STAFF REPORT SAN CLEMENTE ZONING ADMINISTRATOR

-
- PLANNER:** Kirt A. Coury, Contract Planner *KC*
- SUBJECT:** **Minor Cultural Heritage Permit (MCHP) 16-372, Pacific Building Patio** a request for exterior changes to demolish a portion of a commercial building and construct an outdoor patio at the rear facing the alley.
- LOCATION:** 120 South El Camino Real
- ZONING/GP:** Zoning: Mixed Use with Architectural and Central Business Overlays (MU 3.0-CB-A).
General Plan: Mixed Use with Architectural and Pedestrian Overlays (MU 3.0-A-P).

Design Review Subcommittee (DRSC)

Meeting Date: May 24, 2017

Figure 1 – Friends of the Library Wrought Iron Illustration

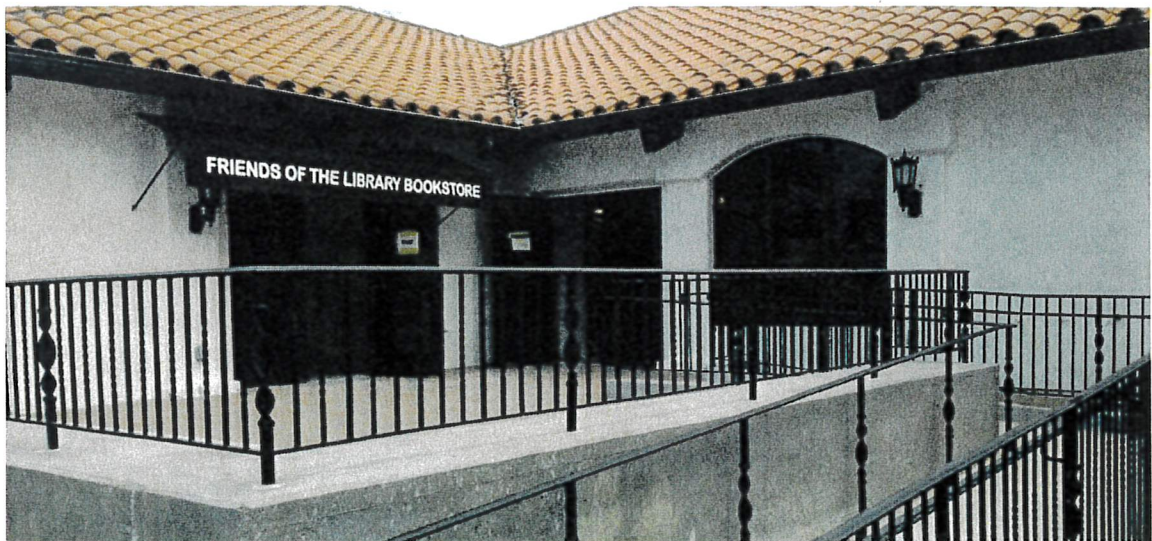
Recommendation:	Applicant Response:
2. Metal hand rail should not be two inch by two inch metal. Metal rail should be solid wrought iron to match traditional look.	No response provided.

1. Revise the metal hand rail to a more traditional look. Staff recommends the applicant match the wrought iron detail used at the library in front of the “Friends of the Library”. Refer to Figure 1 below:

8. The applicant shall utilize a black wrought iron railing to match traditional Spanish Colonial Revival Architecture Design Guidelines, as identified in the May 24, 2017 Design Review Subcommittee staff report. ■■(PIng.) _____
